**Re: BG 22-104- Christian Co. - New Consolidated High School
Design Development Review - Response**

The following is our response to your Schematic Design Review Dated 3/7/22, item by item:

Item 4R - A100F
1/8" = 1'-0"

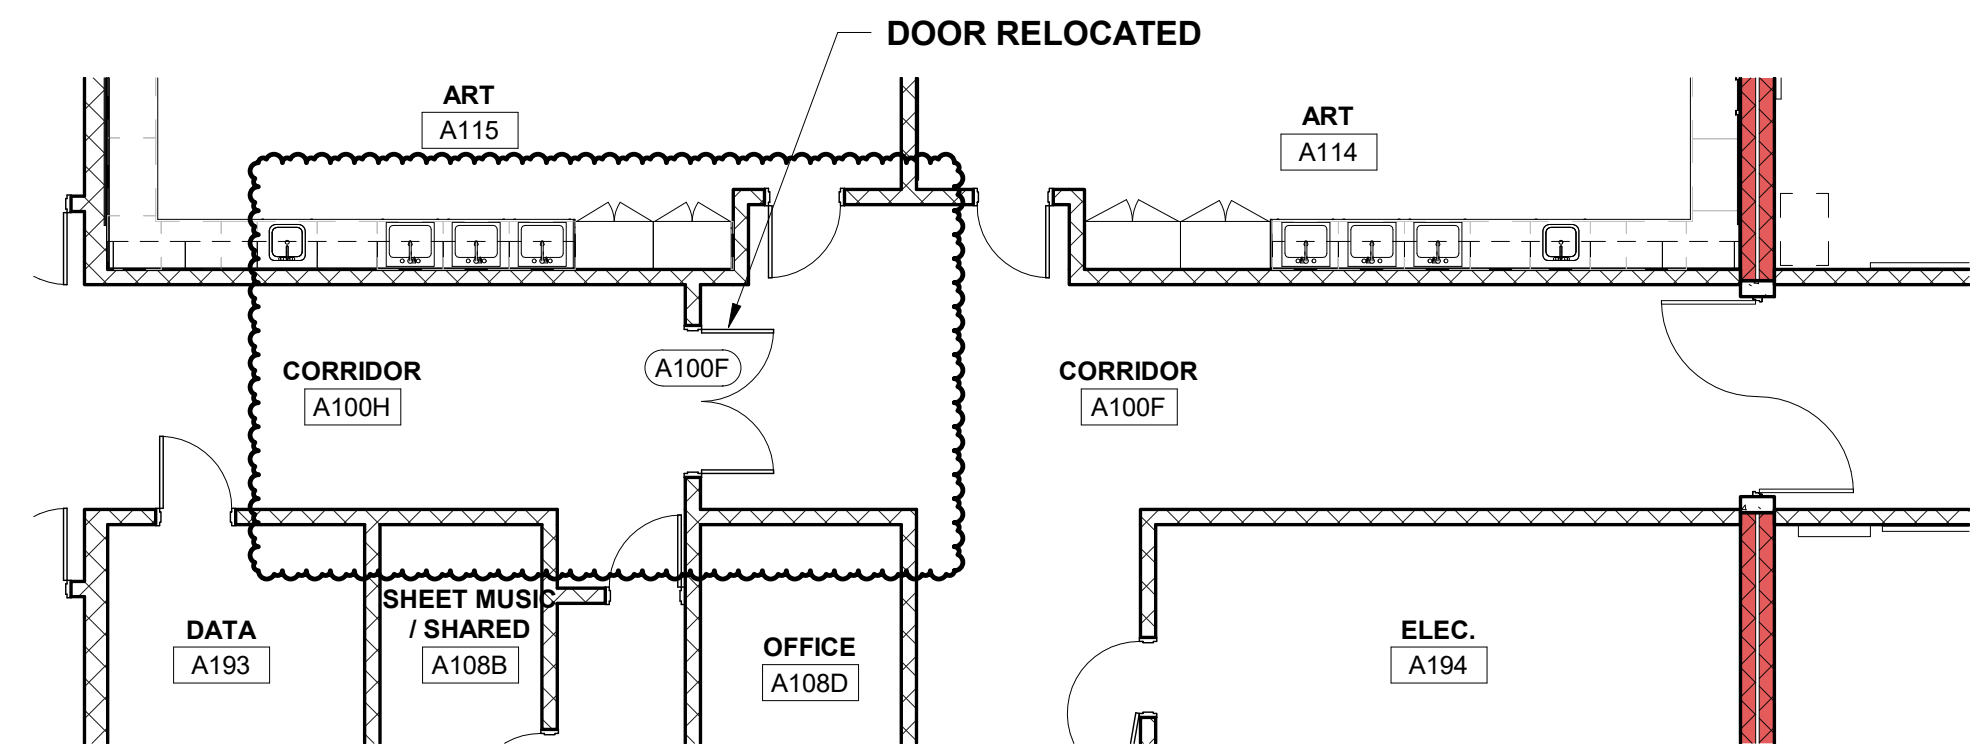
RESPONSE ITEM 4R: Part 2c.1.1.3 – “Corridors shall terminate at an approved egress or at a stairway which leads directly to an approved egress.” Corridors A100F, E100C, E100D, F100C, F100D, F200C and F200 D do not comply with this requirement.

RESPONSE: Door A100F has been moved to reduce the dead end at corridor A100F to an ‘alcove’. E100C & E100D have been previously revised to eliminate the dead-end conditions. F100C & F200C will include an additional resource room to eliminate the dead-end corridor condition, and the end of F100D has been revised to include a small janitors closet to eliminate the dead end condition. See attached floor plans for revisions to each location (Sheet DDR3 – Items 4R).
